Docket Item #9 A&B
Development Special Use Permit #2004-0048
Street Name Case #2006-0001

Planning Commission Meeting
October 3, 2006

ISSUE: Consideration of a request for approval of a development special use permit, with site plan, for the construction of residential, retail and office uses on Landbay H and part of Landbay I and approval of new street names.

**POTOMAC YARD
LANDBAY H & PARTIAL I - DSUP #2004-0048
STREET NAME - CASE #2006-0001
2501 JEFFERSON DAVIS HIGHWAY**

Figure 5. Location of Proposed Fire Station and Existing Fire Station locations

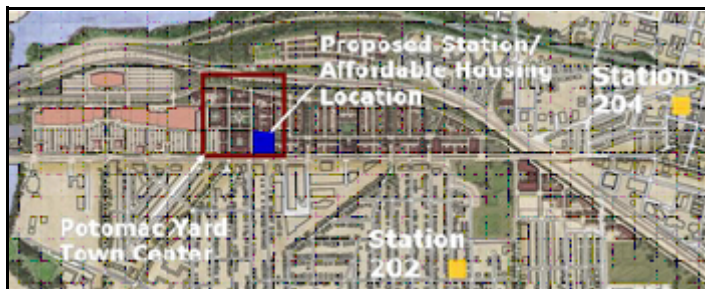
An issue that continues to be discussed is fire for Landbay H and the potential construction of a three-bay fire station within Landbay G. Subsequent to the January 2006 submission of the Landbay H plan and in response to City requirements for fire, the applicant proposed construction of a fire station within

Landbay G. Staff then initiated an analysis of the technical feasibility of a Potomac Yard fire station, including an evaluation of response times, other nearby stations, the City's Capital Improvement Plan, including needed fire station renovations, and fire safety service city wide. One result of the analysis was the potential merger of the Windsor Avenue Station (Station 202) fire and emergency functions with a new Potomac Yard Station.

A thorough analysis of response times (discussed in more detail in the main body of this report), has led staff to recommend that the fire suppression units from the Windsor Avenue Station (Station 202) be relocated to Potomac Yard. Under this scenario, the ambulance-emergency medical services units and accompanying staff would remain at the Windsor site.

Figure 23: Turning Movements of Fire Trucks traveling South

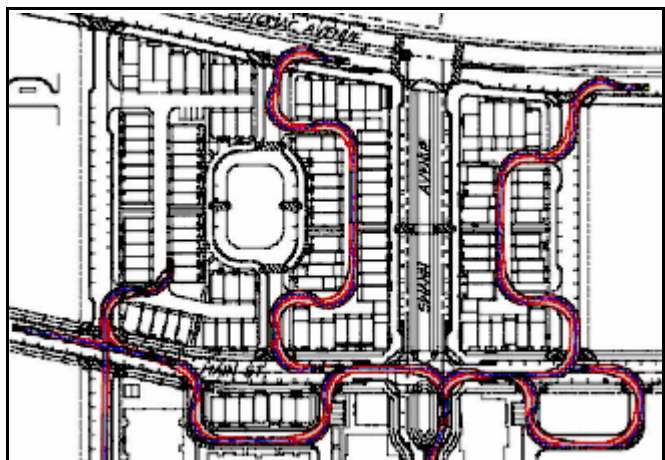
The original fire station idea responded to site planning issues in the Landbay H design as currently proposed. The size and shape of several corners, specifically where alleys meet residential streets, and the fact that townhouse buildings are located close to the street create some difficult and tight turning movements for fire trucks. Although the units are being

built with sprinkler systems, the City requires that improved fire to the alleys also be made available.

One solution is for the alleys to be made larger, and to reduce the number of townhouse units. Staff did not support that solution, because the result is a more suburban design solution. The alternative solution to wider alleys is the construction of a new fire station in Landbay G (Town Center) of Potomac Yard to reduce response time to fires within Potomac Yard. Analysis of this proposal showed that a new station in the Yard would not only address the time delays that might come about as a result of the turning radius problem at Potomac Yard, but would also increase fire to Del Ray and the city as a whole, save money long term, and accommodate additional affordable housing units.

Figure 25. Turning Movements

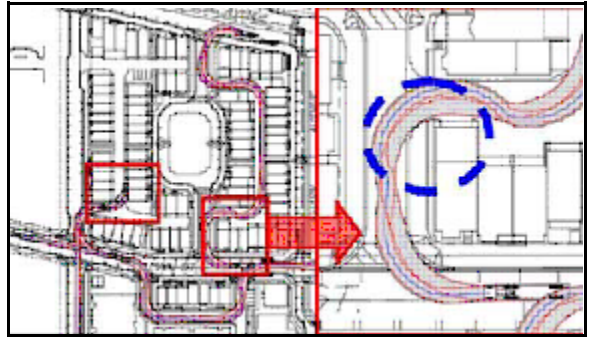
One of the issues raised has been whether the rights-of-ways are too narrow in Landbay H. The streets in Potomac Yard are 64 ft. (or wider), comparable to the typical 66 ft. right-of-way width in Old Town, which clearly accommodates fire trucks adequately. The area of conflict that leads to the fire issue is the geometry of the curb radii of the blocks in Potomac Yard, in relation to the length of the fire trucks.

Computer-simulated models reflecting the conflict show the worst-case scenarios with the largest apparatus owned by Arlington, Fairfax and Alexandria. As such, these models account for the rare times when the conflicts could occur. In part, the turning radius is impacted by the proximity of the buildings at the alley opening and at the turning radii. The purpose of the urban alley dimensions is to have the terminus of the alleys unnoticed or “hidden” by screening the views of the alleys.

Figure 26. Alternative Solutions (units removed shown in red, parking spaces removed shown in green)

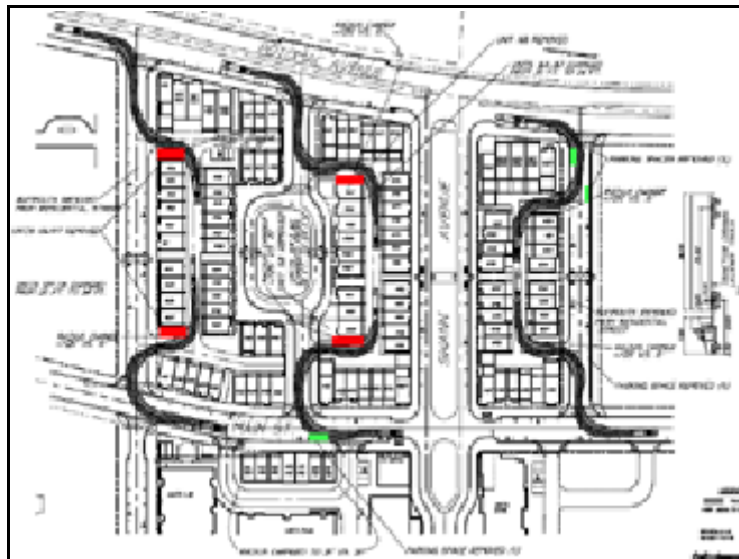
The community wanted to know whether Landbay H can move forward without the new fire station. If the fire station is not approved, the applicant will need to revise the site plan for Landbay H to meet emergency vehicle turning radii within the streets and alleys of the project. A preliminary plan revised to show the impacts to the site plan is included in this report. Four residential units will be removed, additional landscaping and screening will be required for the alleys, and approximately 5 to 10 parking spaces on several streets will be lost as part of this site plan revision.
